CHANNEL 1 INPUT AMPLIFIER

Type 422 | **PRODUCT MODIFICATION INDEX**

FIG. 1

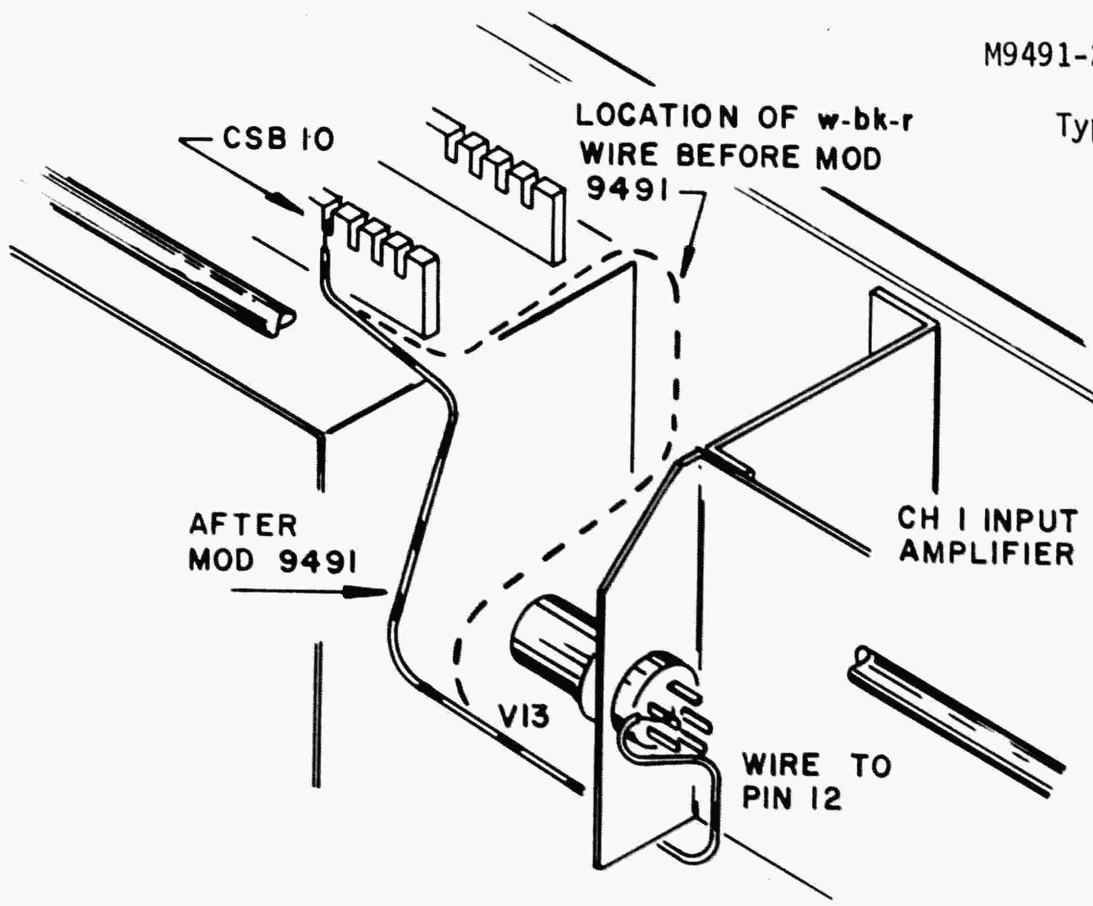
- Install a new 5-1/2inch #26 stranded white-black-red wire between CSB-10 and pin 12 of V13, referring to Fig. 1 for the proper routing and dress.
- Remove the #26 white-red-black-black wire from pin M of the Calibrator-Regulator board, located behind the timing switch.

FIG. 2

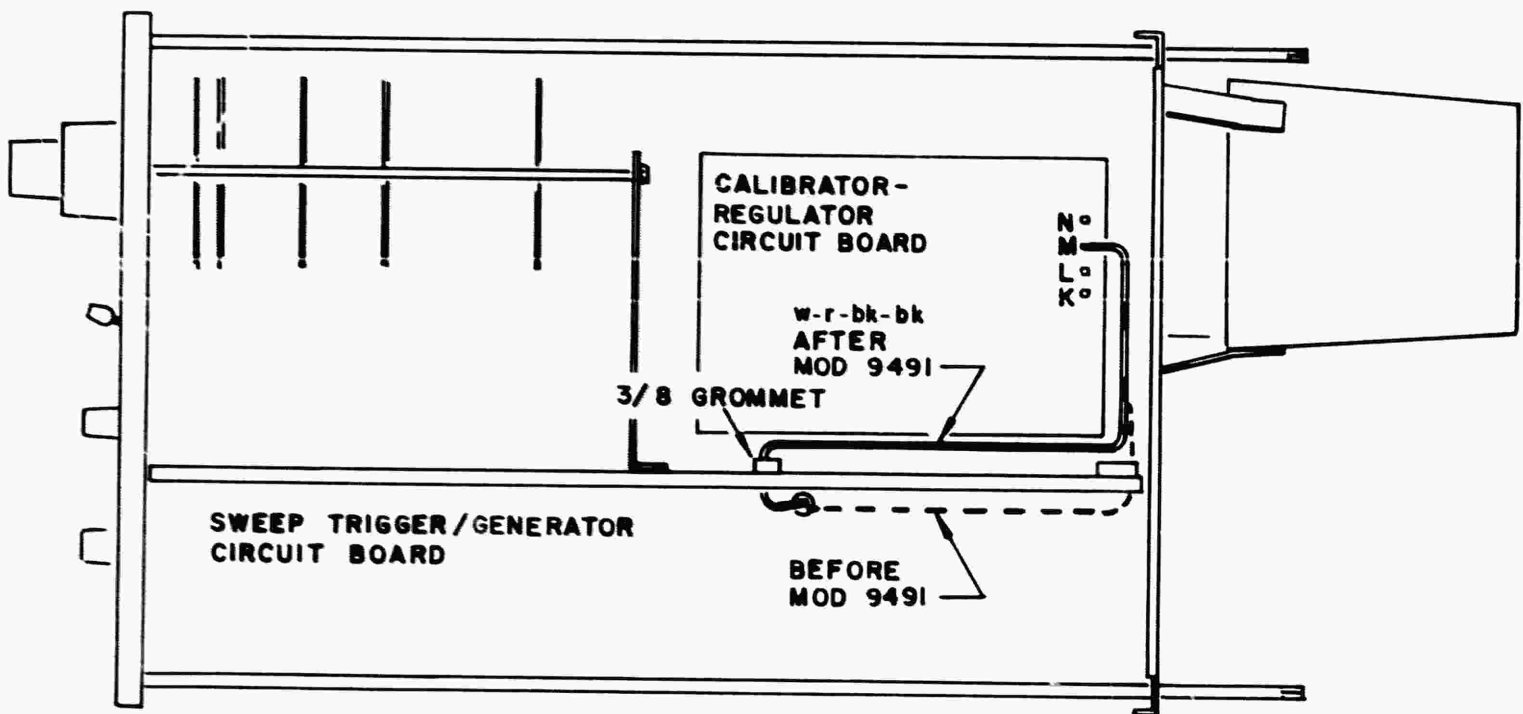
- Cut the connector off of the wire immediately behind the connector and remove the wire from its cable back to the point where the cable passes below a 3/8" grommet in the instrument chassis near pin Y of the Sweep Trigger/Generator circuit board. See Fig. 2.

422 ATTENUATOR ASSEMBLY  
(BEFORE MOD)

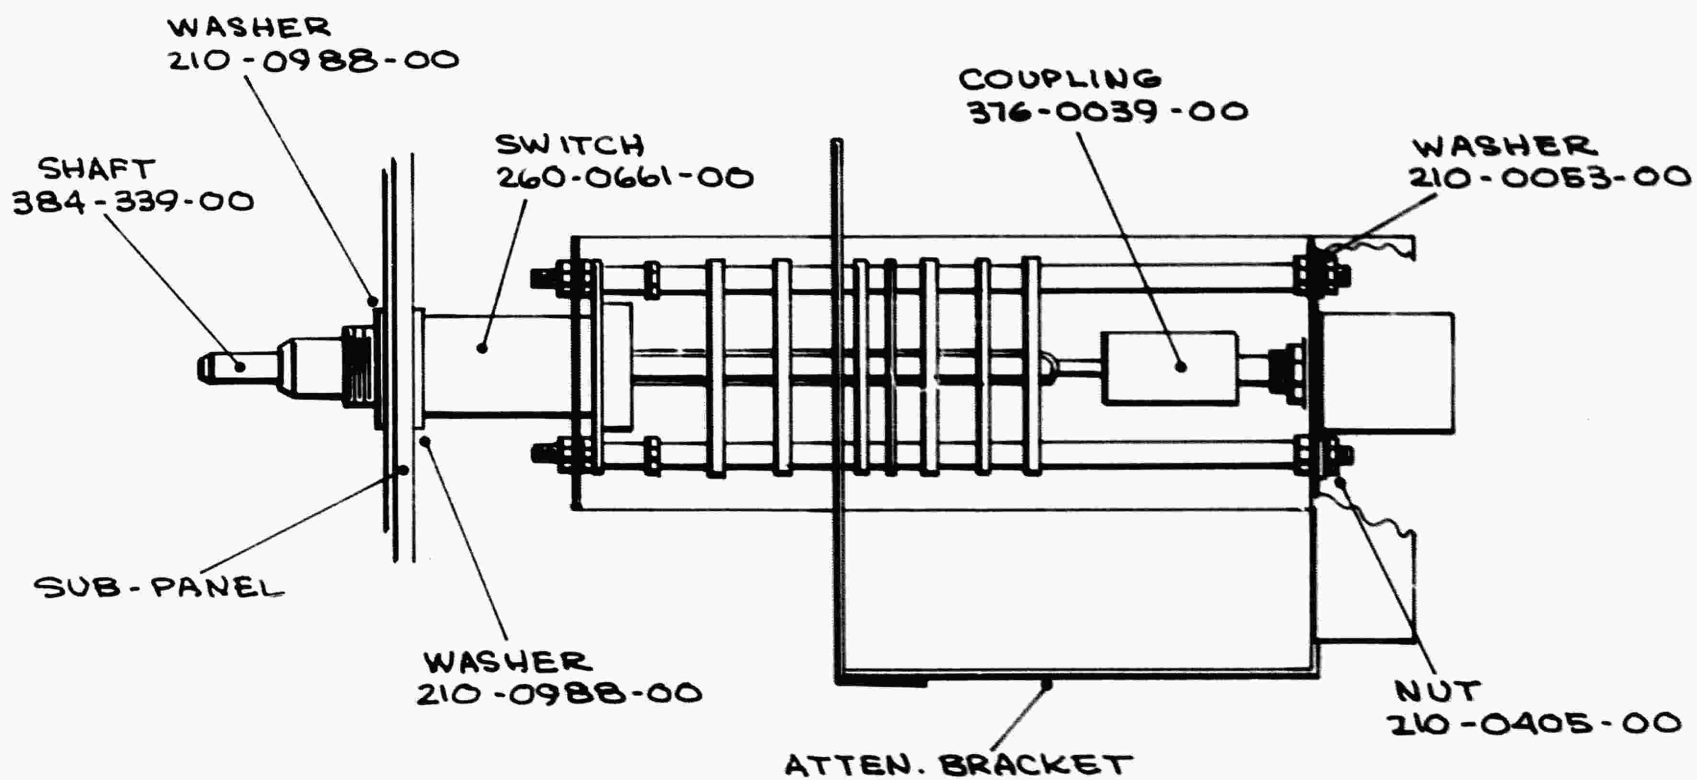
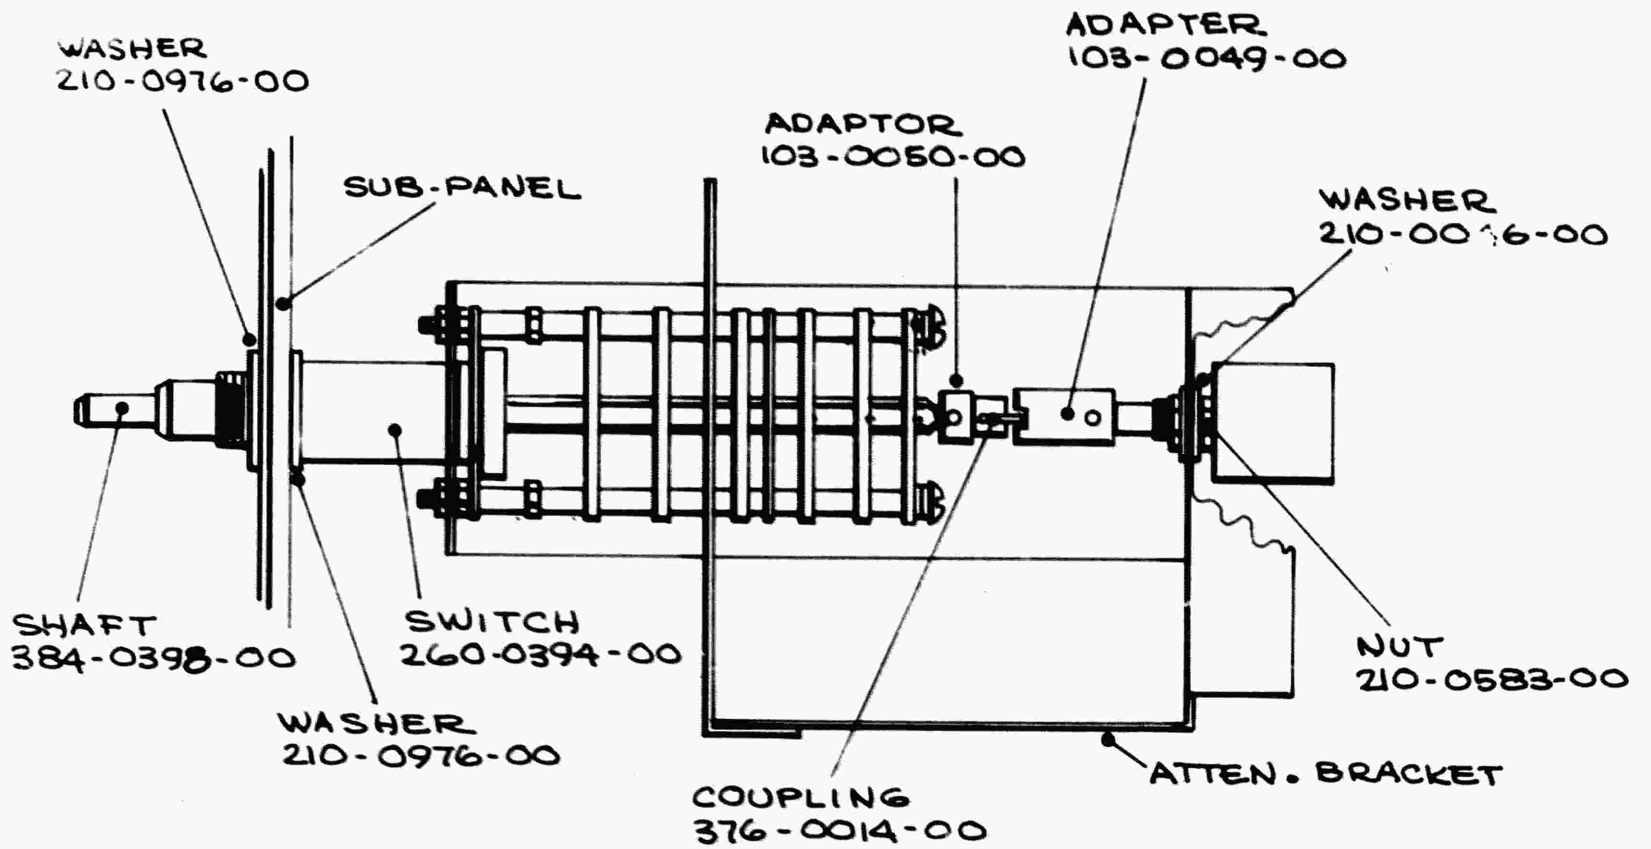
M9883 (Continued)

FIG. 4

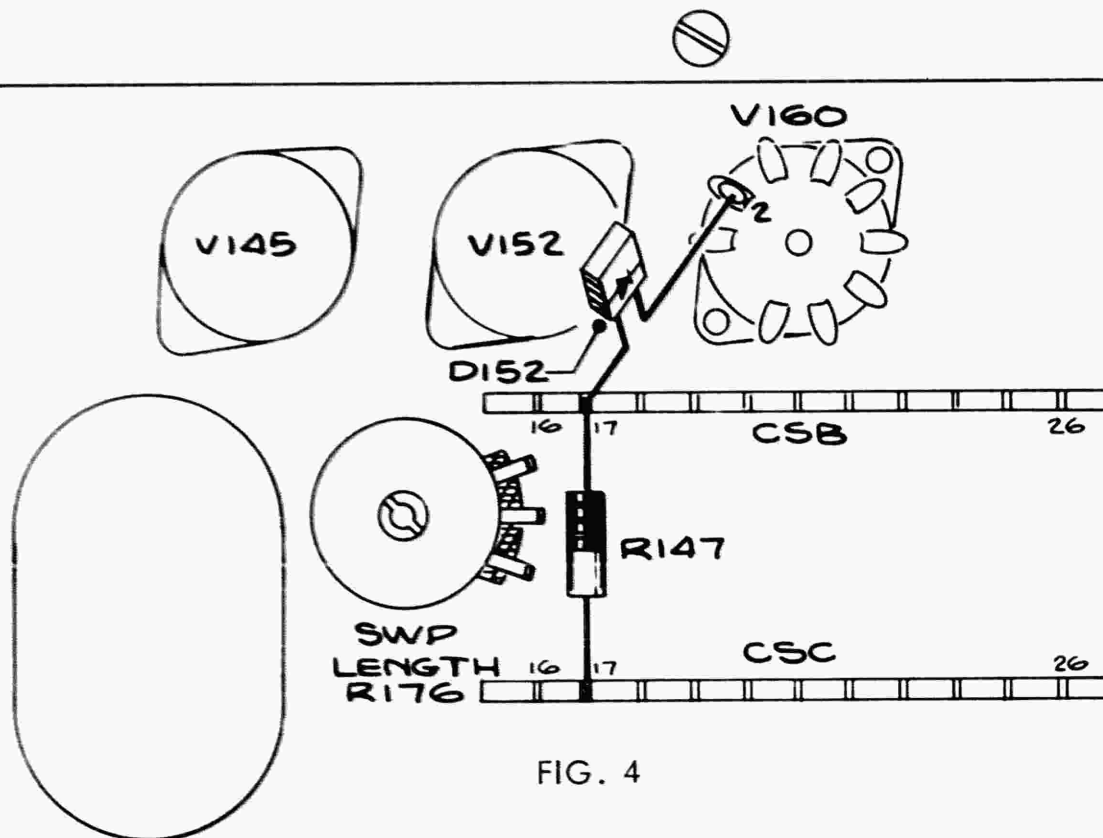
Replace the following components with parts from the kit (see Fig. 4):

FIG. 5

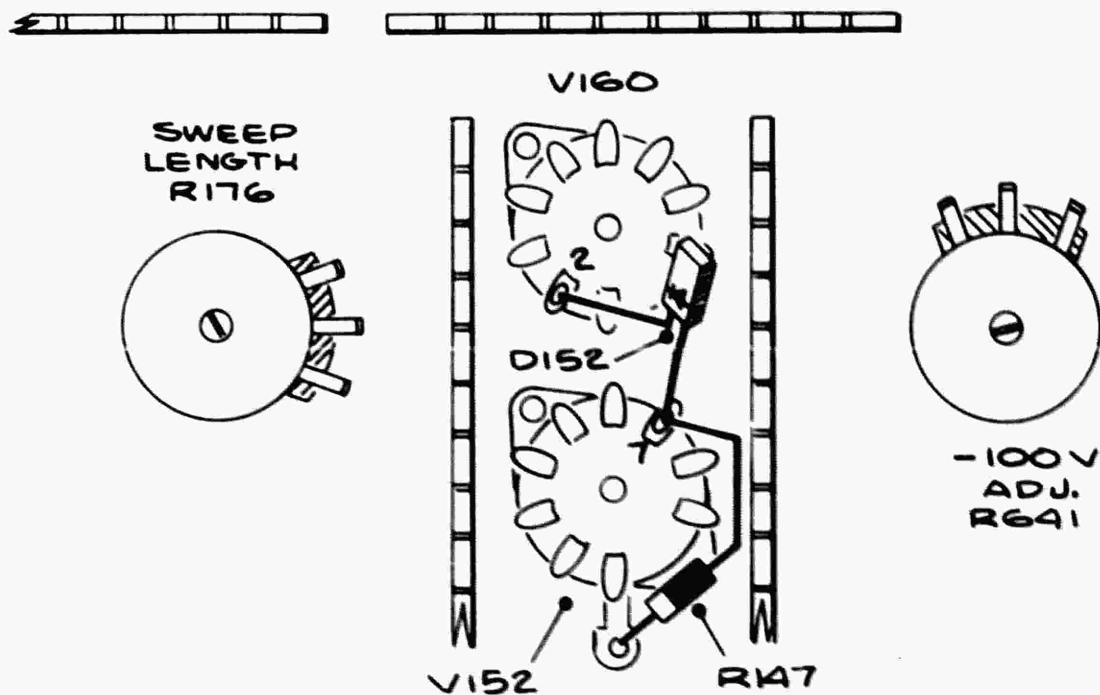
- ( ) R147, 1.5k 1/2W 10%, with 1k 1/2W 10% resistor.
- ( ) D152, single diode, with diode assembly.

FIG. 1

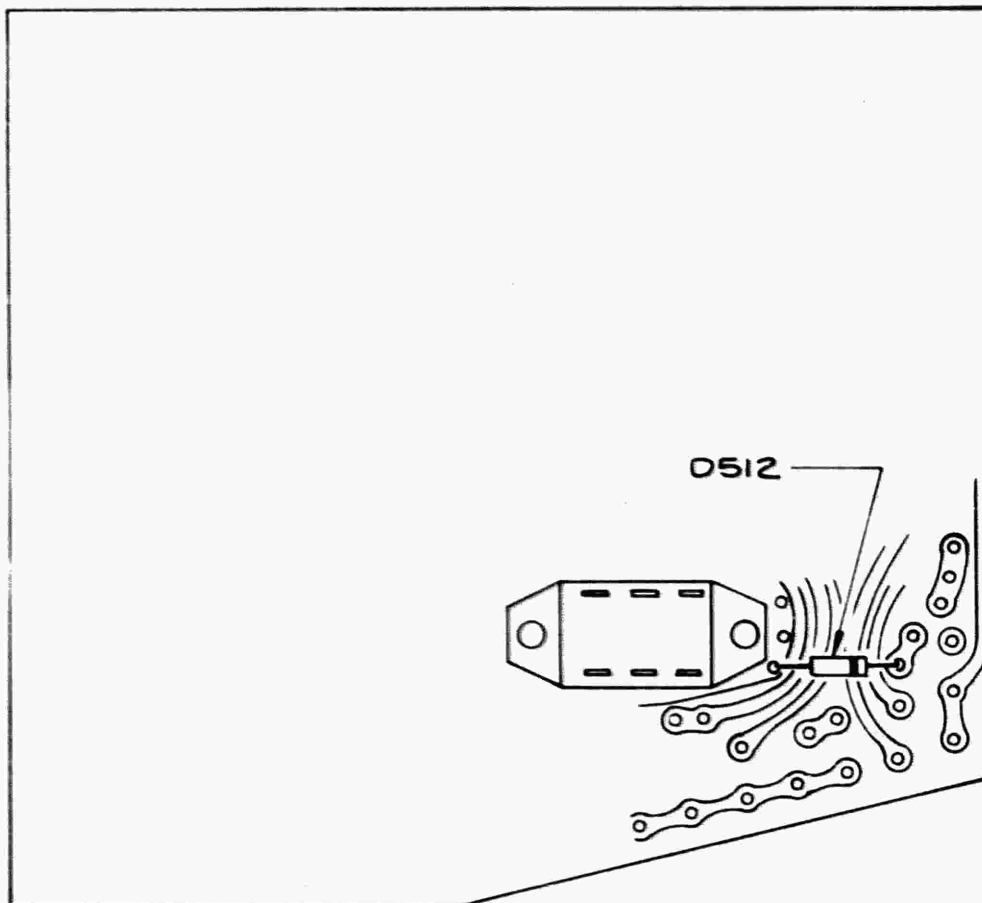
- Remove D512, a 6185 diode, from its location as shown in Fig. 1.
- Remove the three mounting screws from the Horizontal Amplifier circuit board and lift the board so the bottom side is readily accessible.
- Install D512 (removed in step a) between the emitter and base of Q513 as shown in Fig. 2.
- Install D524, a 6233 diode, between the base and collector of Q524 as shown in Fig. 2.

M10230 (Continued)

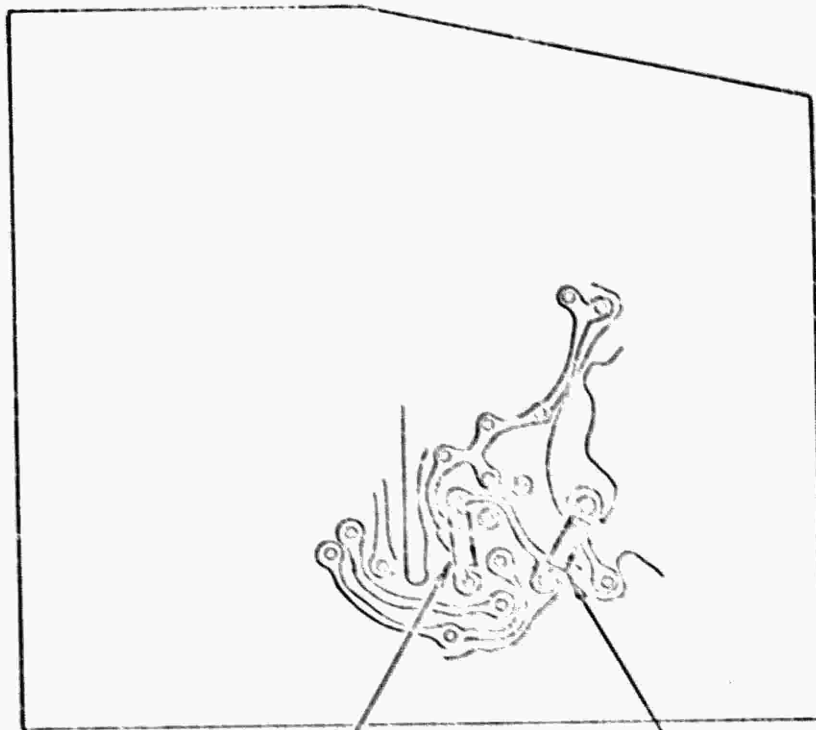
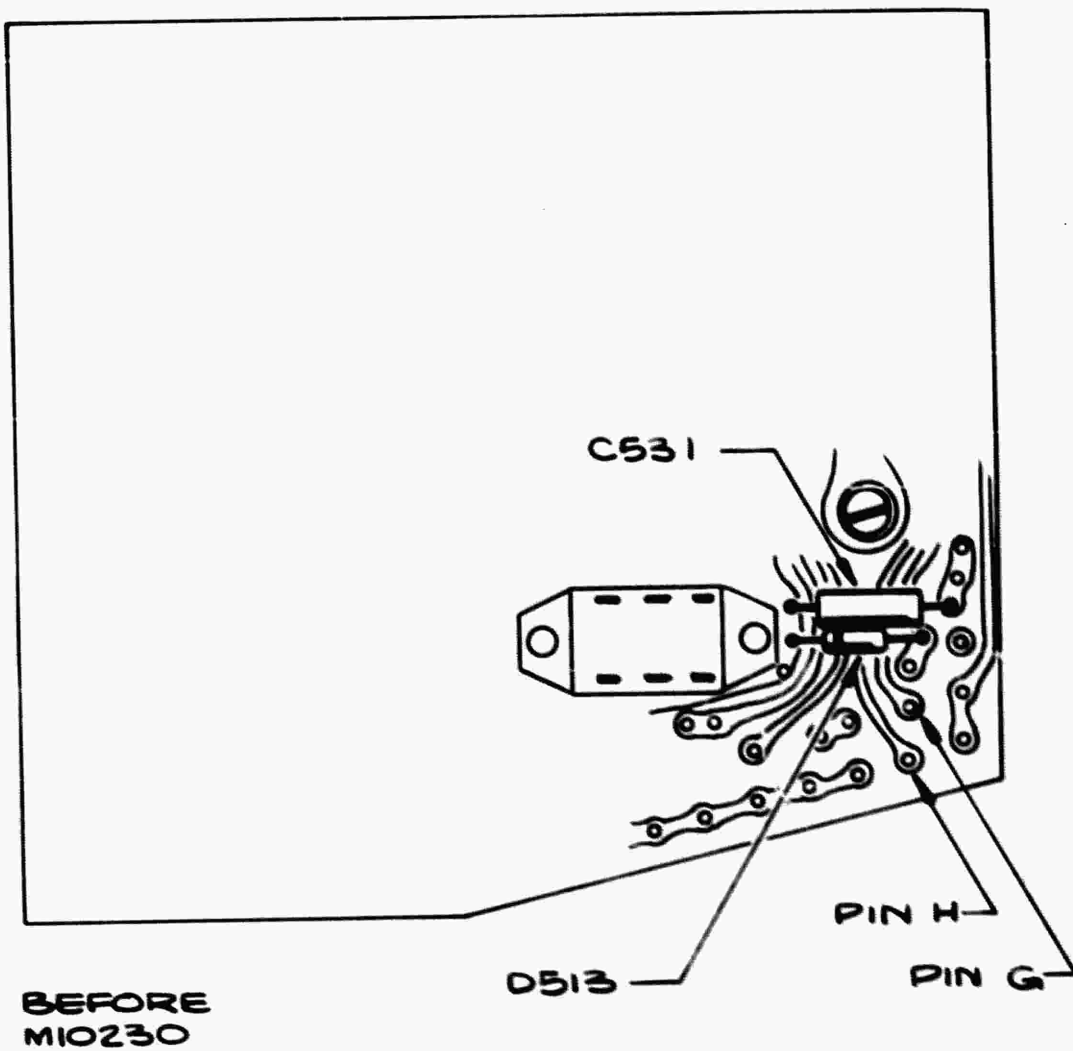
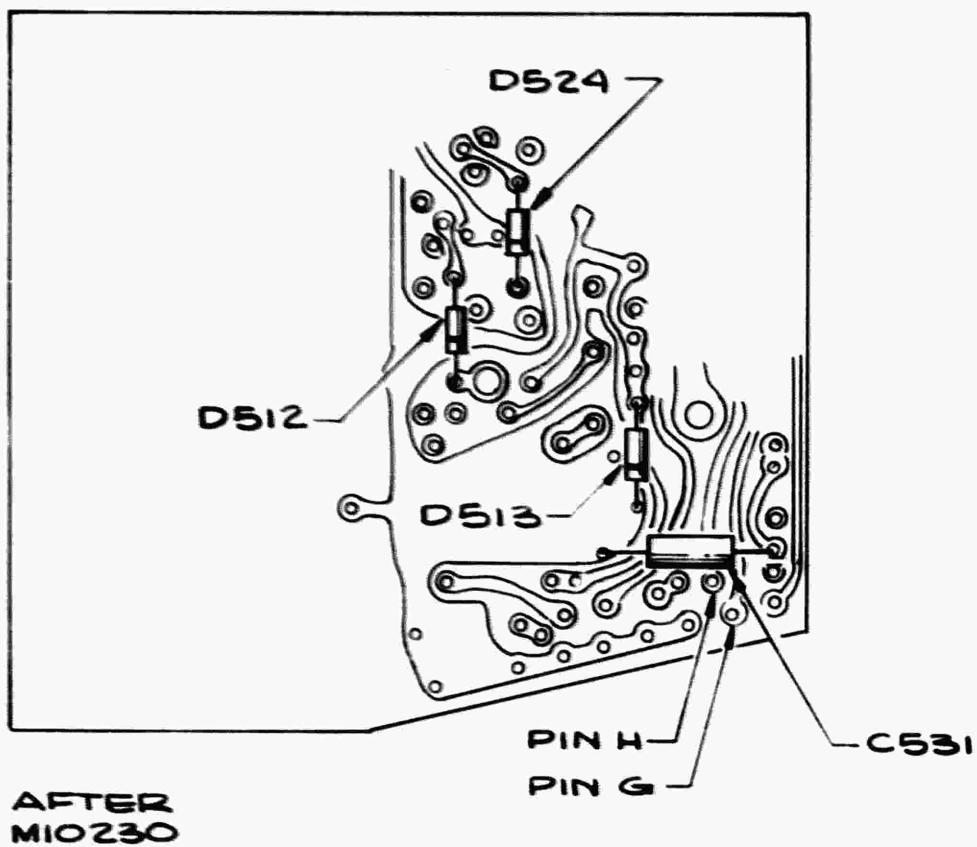
D512, D513, D524 and C531 were relocated as shown on before and after drawings. To provide more space for relocated components, transistor sockets for Q513, Q524, and Q543 were changed to a smaller type and the layout of the Horizontal Amplifier board was changed.

FIG. 1

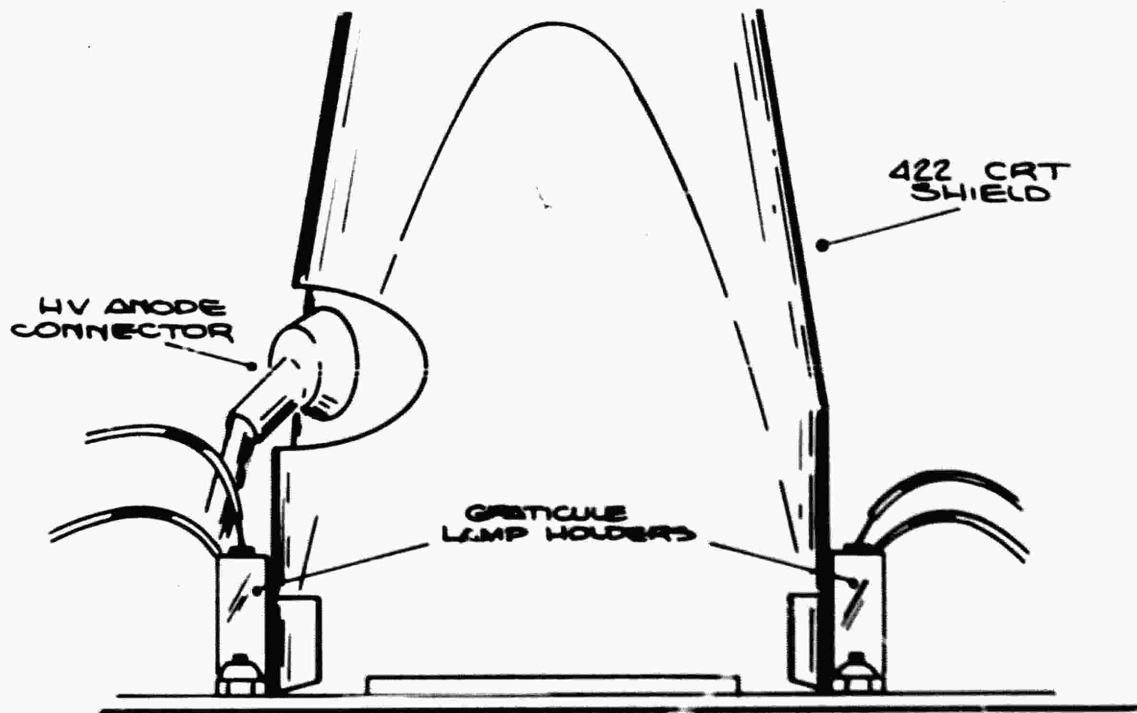
( ) 3. Replace graticule lamps B725 and B726 with the new lamps from the kit.
